SURRY POWER STATION, UNIT NO. 2

AMENDMENT TO FACILITY OPERATING LICENSE

Amendment No. 59
License No. DPR-37

ATTACHMENT TO LICENSE AMENDMENT NO. 59

FIGURE 3.8.2-1 (Continued)

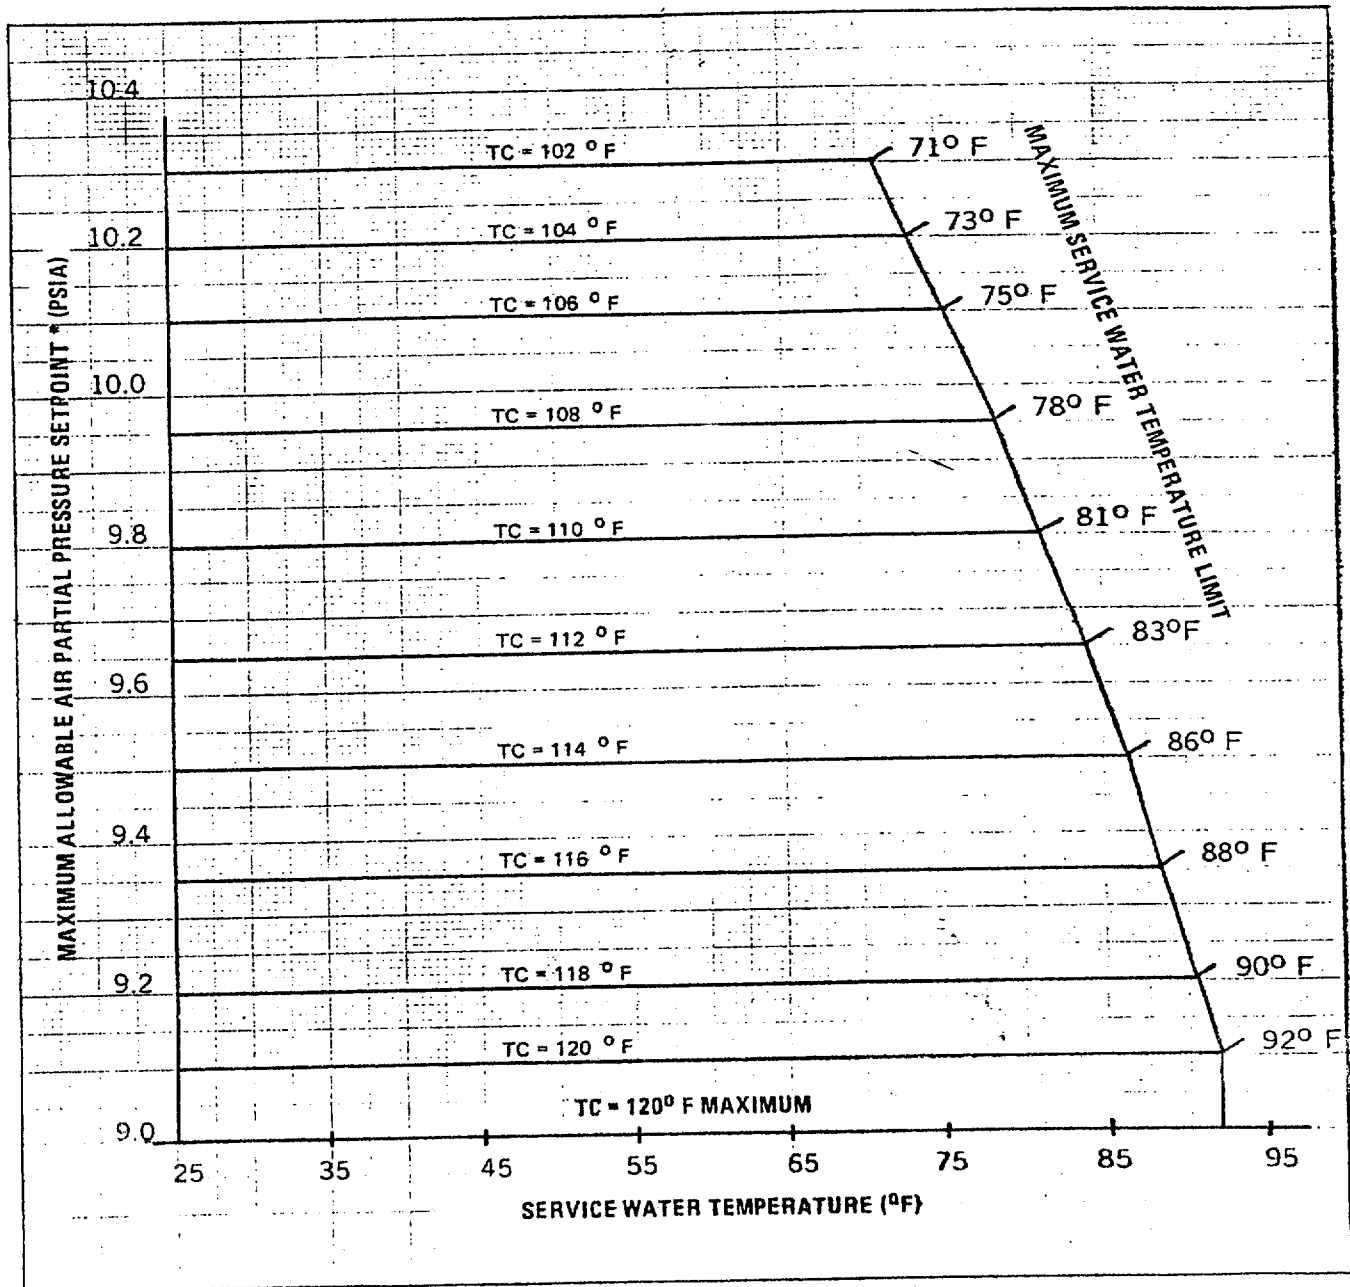
The maximum allowable set point for the containment air partial pressure is presented in Figure 3.8.2-1 for service water temperature from 25 to 90°F. The allowable set point varies as shown in Figure 3.8.2-1 for a given containment average temperature. The RWST water shall have a maximum temperature of 45°F.

The horizontal limit lines in Figure 3.8.2-1 are based on LOCA peak calculated pressure criteria, and the sloped line is based on LOCA subatmospheric peak pressure criteria.

From Figure 3.8.2-1, if the containment average temperature is 112°F and the service water temperature is less than or equal to 83°F, the air partial pressure set point value shall be less than or equal to 9.65 psia. If the average containment temperature is 116°F and the service water temperature is less than or equal to 88°F, the air partial pressure set point value shall be less than or equal to 9.35 psia. These horizontal limit lines are a result of the higher allowable initial containment average temperatures and the analysis of the pump suction break.
